PARTIAL ANCHOR BOLT SETTING PLAN (LEVEL-M3) (SECTOR-A)
(REFER SHEET: S-A-2522)

PARTIAL ANCHOR BOLT SETTING PLAN (LEVEL-M3) (SECTOR-A)
(REFER SHEET: S-A-2512 & S-A-2534)

ANCHOR BOLT SETTING KEY PLAN (SECTOR A-B-C)

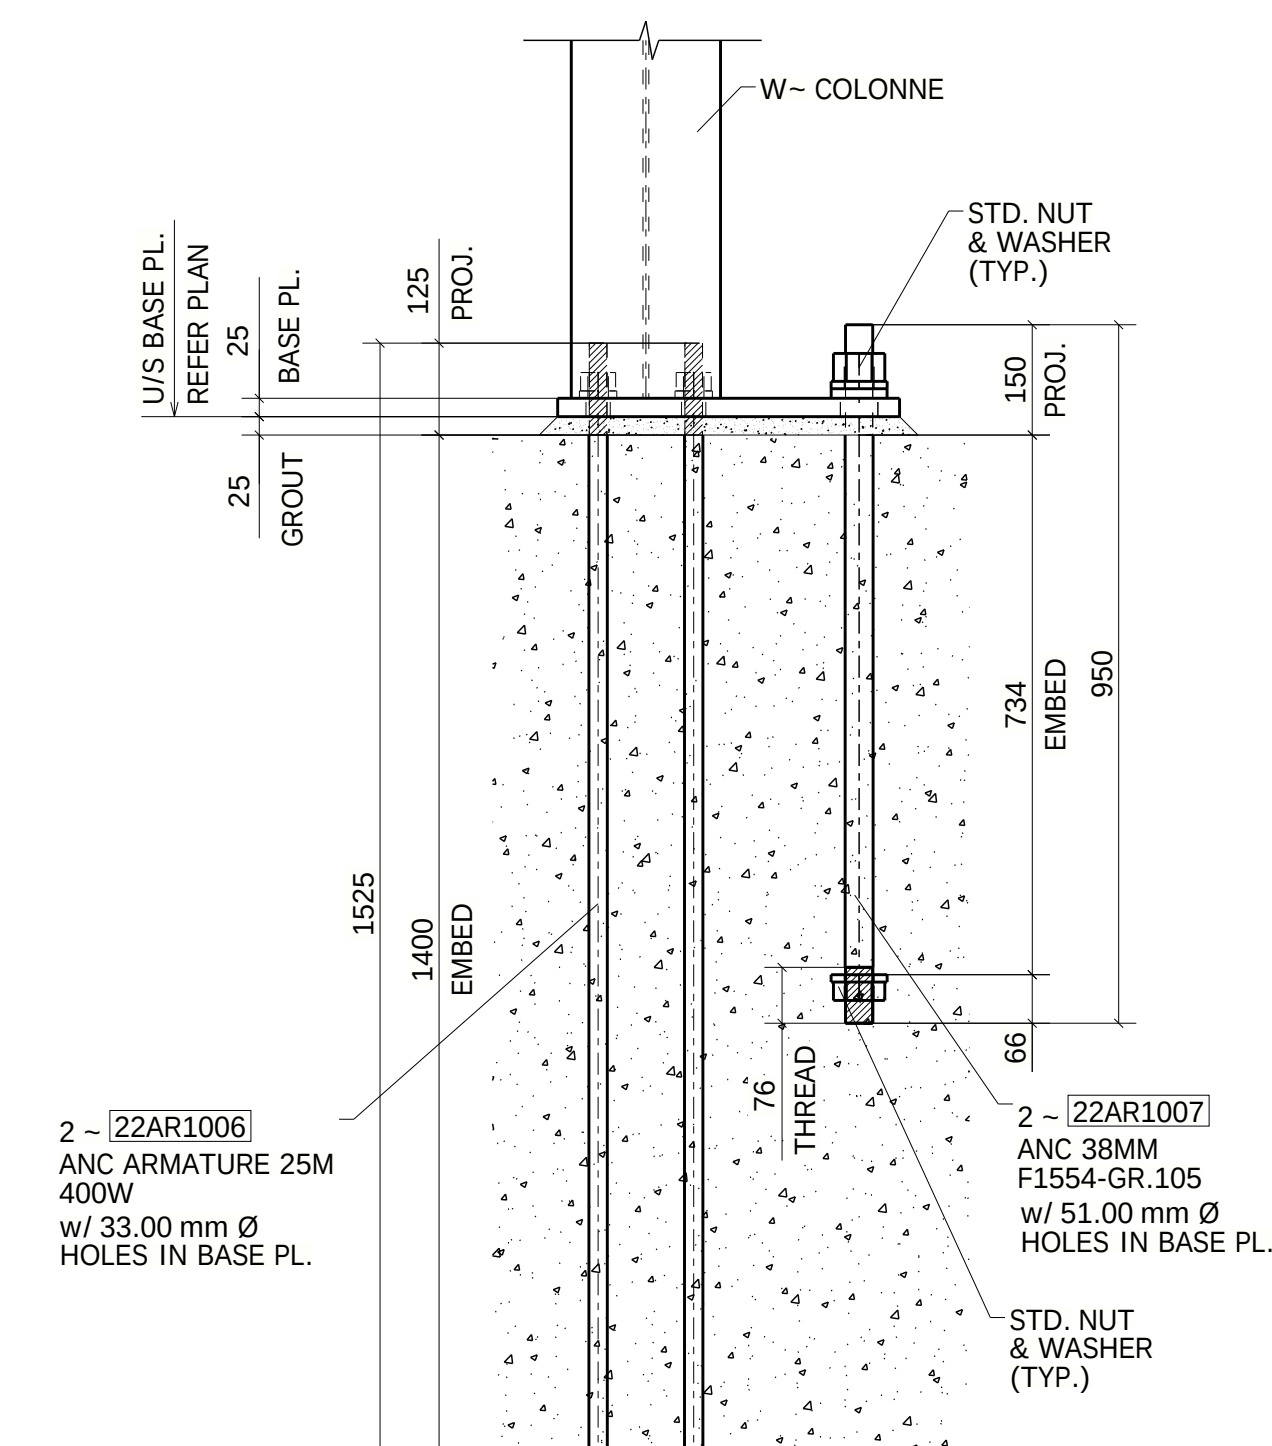
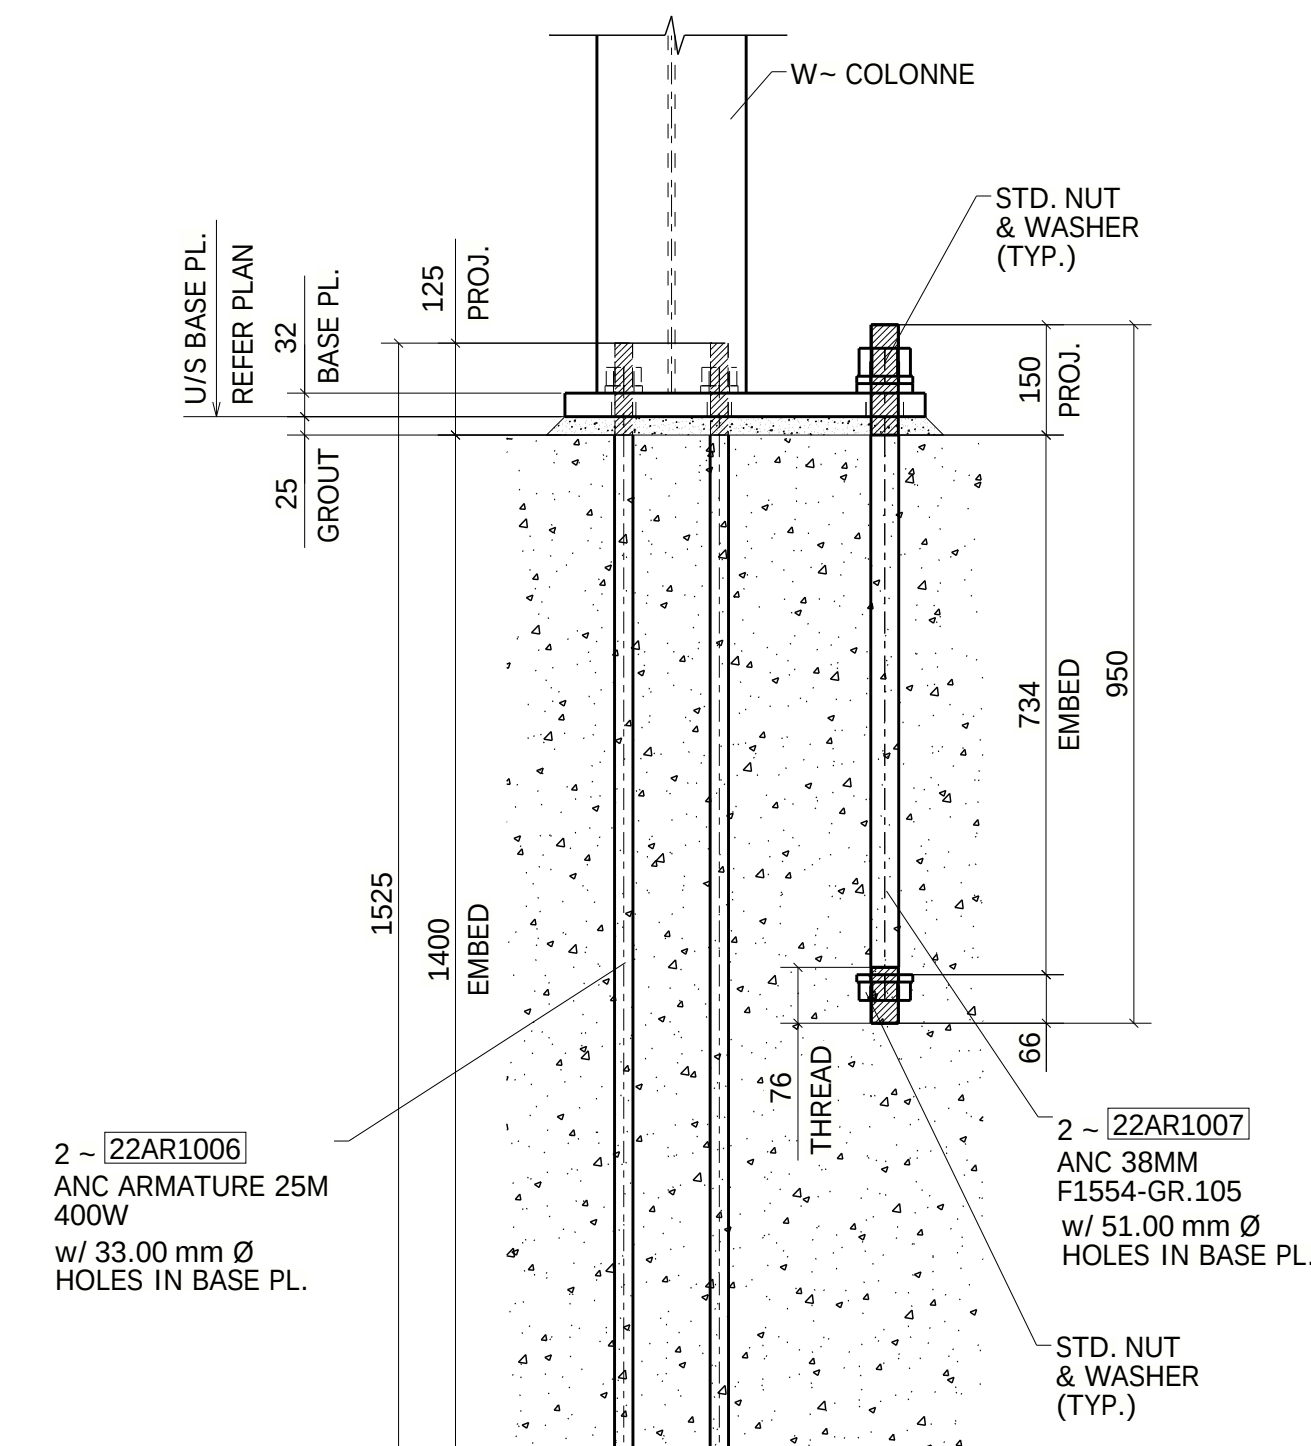
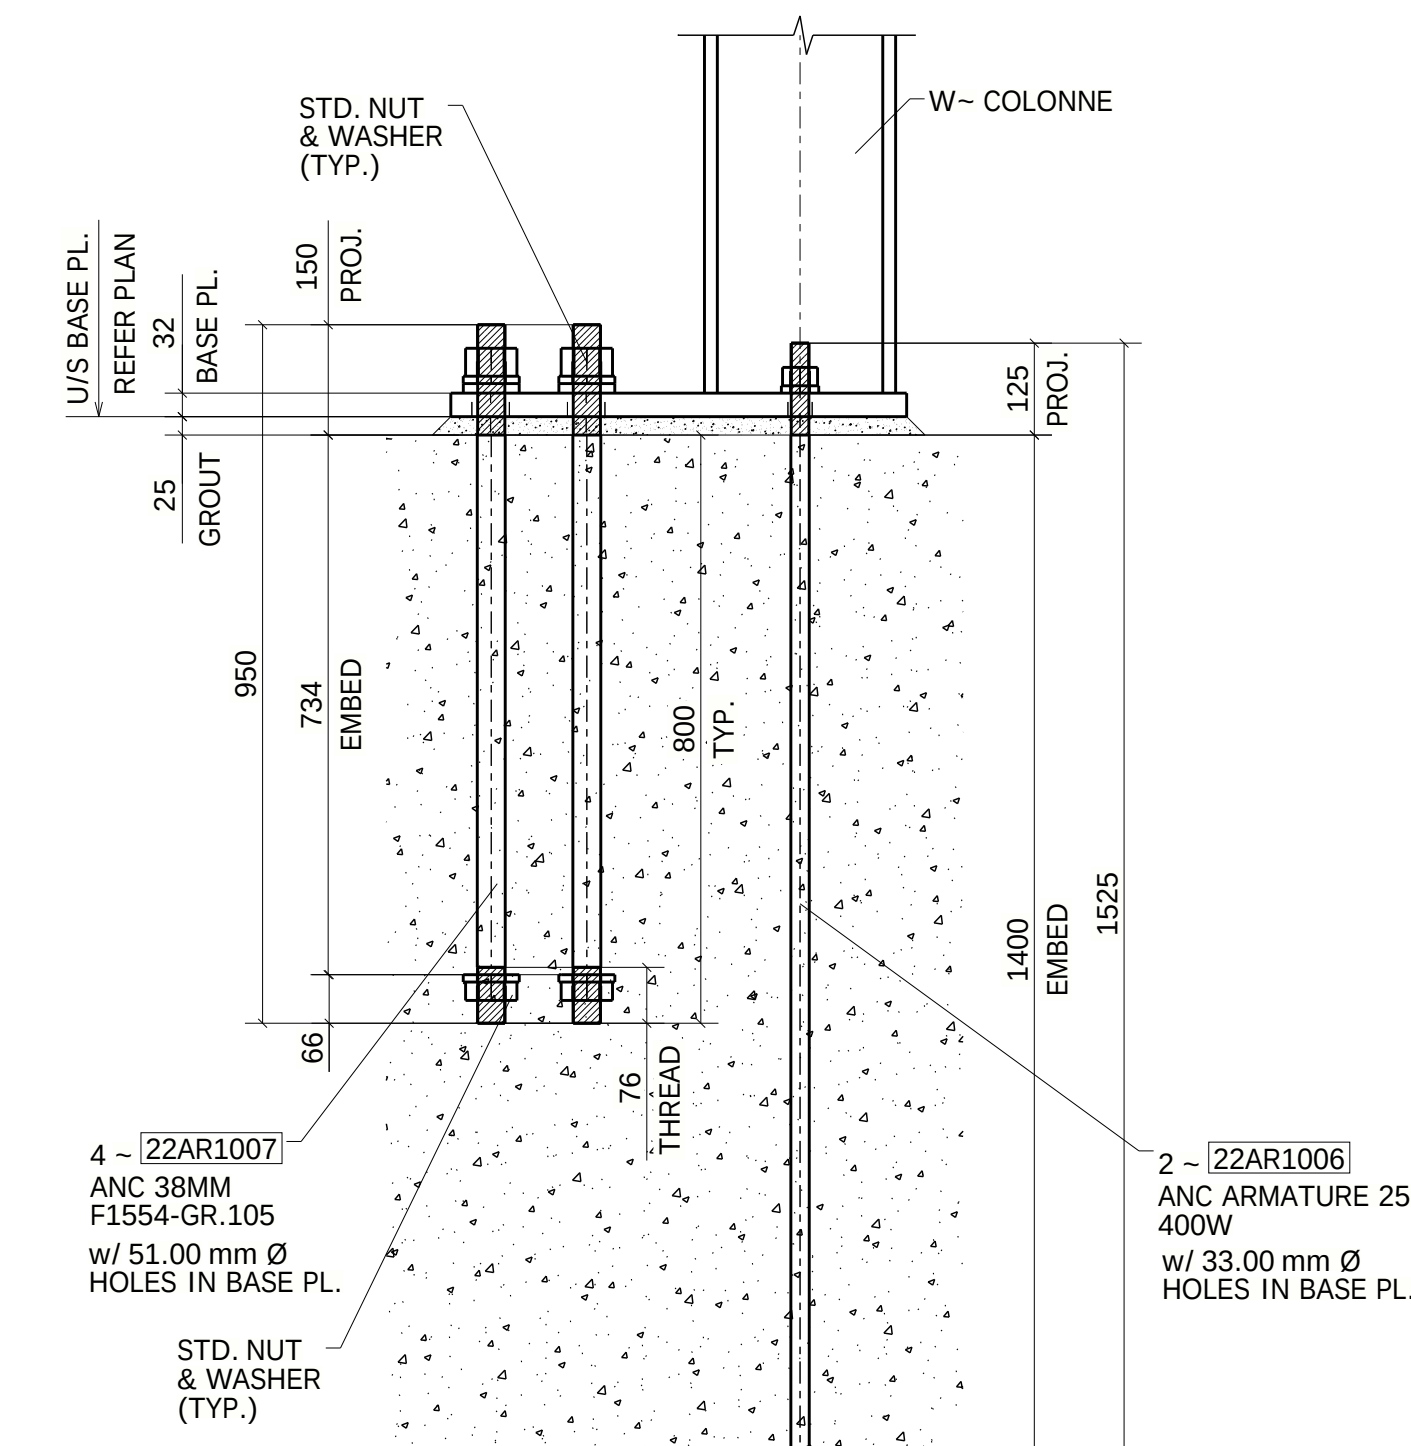
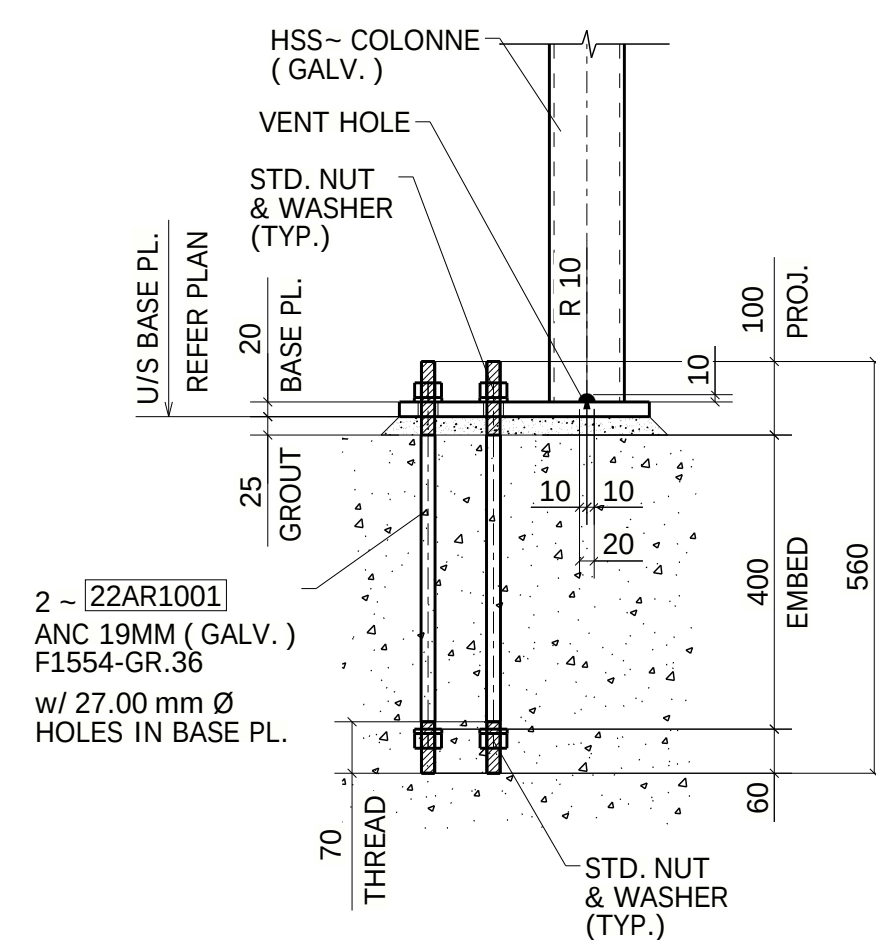
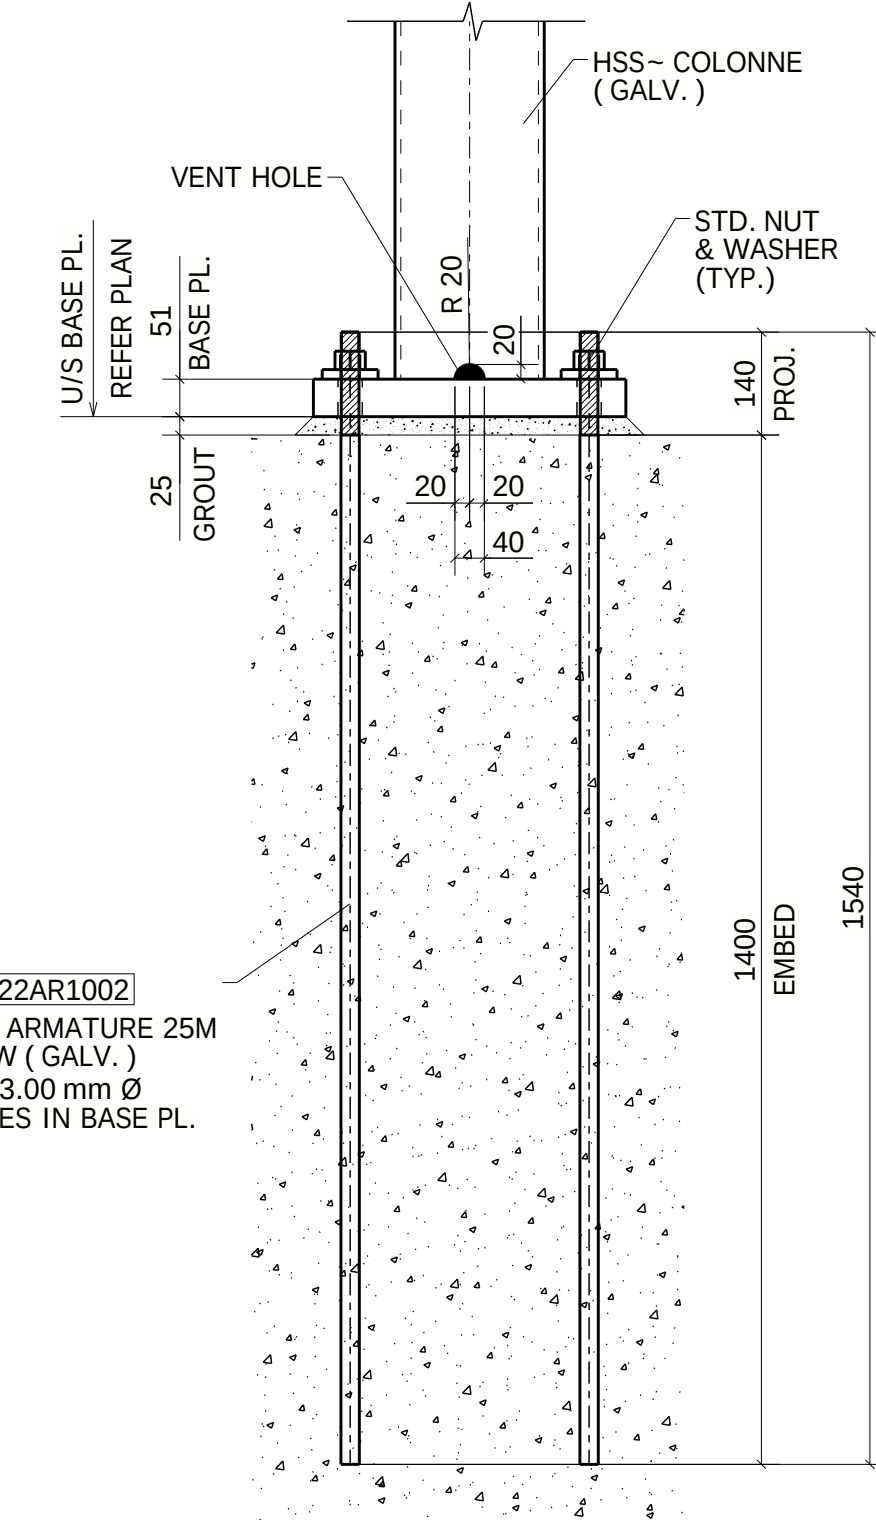
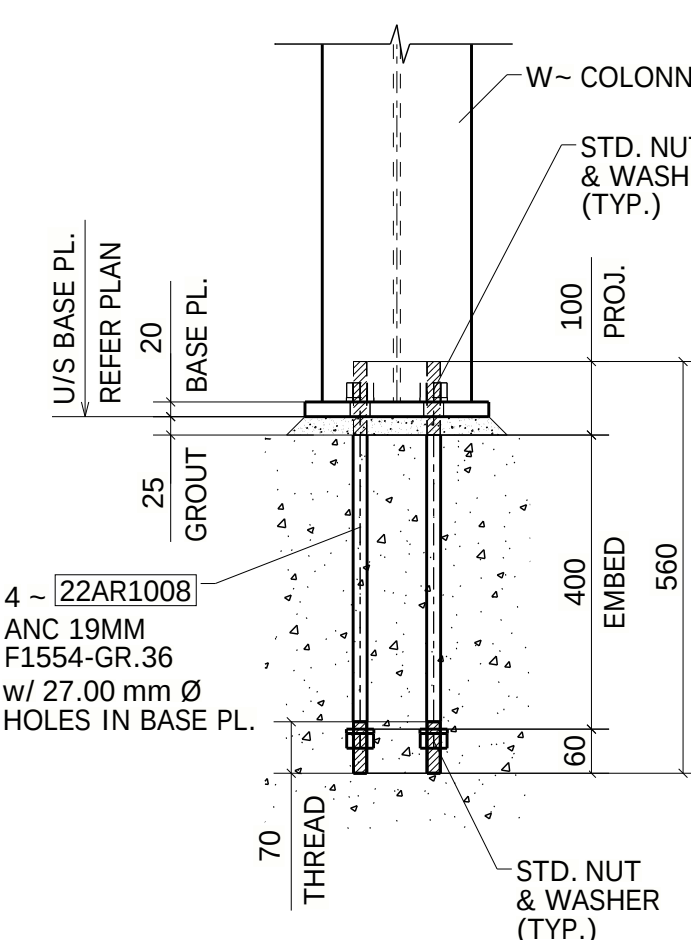
Q-1 APPROVER VERIFY THREAD LENGTH.

Q-2 APPROVER VERIFY ANCHOR ROD LENGTH.

Q-3 APPROVER VERIFY PROJECTION LENGTH. SINCE STRL.SHEET DOES NOT HAVE INFORMATION.

Q-4 APPROVER VERIFY PLATE WASHER PROFILE USED. SINCE STRL.SHEET DOES NOT HAVE INFORMATION.

Q-5 APPROVER VERIFY ANCHOR ROD MATERIAL GRADE USED.

Q-6 APPROVER VERIFY THIS DIMENSION.

Q-7 APPROVER VERIFY REQUIREMENT OF GALVANIZE FOR ANCHOR ROD. SINCE HAND SKETCH (PL-07) DETAIL SHOWS BASE PLATE IN GALVANIZE SINCE COLUMNS ARE NOT GALVANIZED AT (PL-7) LOCATION.

Q-8 APPROVER VERIFY ANCHOR ROD HOLE SIZE IN PLATE.

Q-9 APPROVER VERIFY ROD LOCATING DIMENSIONS.

Q-10 APPROVER VERIFY REQUIREMENT OF WELD. IF YES PLEASE VERIFY WELD DETAILS.

Q-11 APPROVER VERIFY ROUND SLEEVE PROFILE USED.

Q-12 APPROVER VERIFY ANCHOR ROD LENGTH AT TYPE-1A LOCATION. SINCE WE HAVE FOLLOWED 798mm LENGTH ANCHOR ROD AT NO ABAQUE LOCATIONS.

Q-13 APPROVER VERIFY WE ARE PROVIDED NON GALV. ANCHOR PLATE AND ROD. EVEN THOUGH COLUMNS ARE IN GALV. PLEASE VERIFY AND CONFIRM.

APPROVER VERIFY/FURNISH ALL CLOUDED INFORMATIONS
